TVA EMPLOYEE CONCERNS
SPECIAL PROGRAM

REPORT NUMBER: CO19201-SQN

REPORT TYPE: Sequoyah Nuclear Plant Element
(Final Report)

TITLE: Conduit

Figure 3.2.6-1

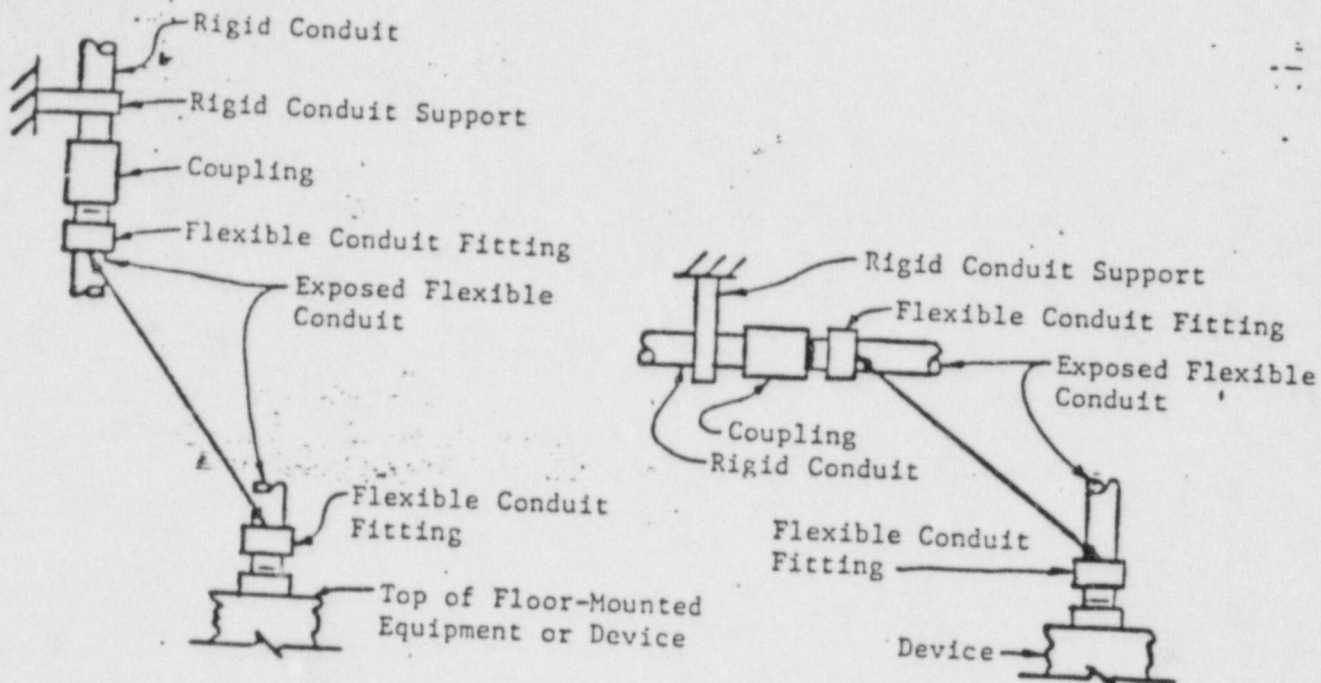
Figure 3.2.6-1, Page 3-12 - Delete figure and note.

Table 3.2.6-1

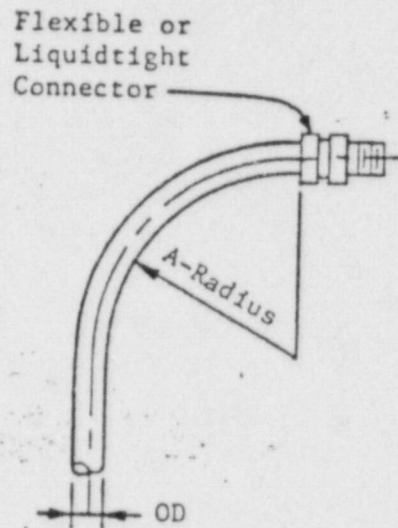
Contrary to the requirements of SMI-0-317-33, Rev. 1 related to flexible conduit installation deficiencies, the minimum bend radius was not verified in accordance with Table 3.2.6-1 of Attachment 1. (CATD 19201-SQN-08)

Section 3.2.6.3, Pages 3-13 and 3-14 - Replace (existing text, Table 3.2.6-1 and Figure 3.2.6-2) with the following:

- CATD 19201-SQN-08 During the performance of SMI-0-317-33, Rev. 1, the bend radius requirement was inadvertently omitted. After further study, we have decided to eliminate this requirement from the procedure. Flexible metal conduit provides only mechanical protection for cables and no failures have to date been attributed to bend radius violations. Also, in general the seismicity of the equipment does not depend on the bend radius of the flex conduit as long as there is adequate movement (which we have assured) and the flex conduit does not exceed 6'-0". Based on the above, we conclude that this work is not a restart item. After plant restart, a flex bend radius sampling (per MIL STD 105D) will be performed. Estimated completion date for this activity is October 1987.
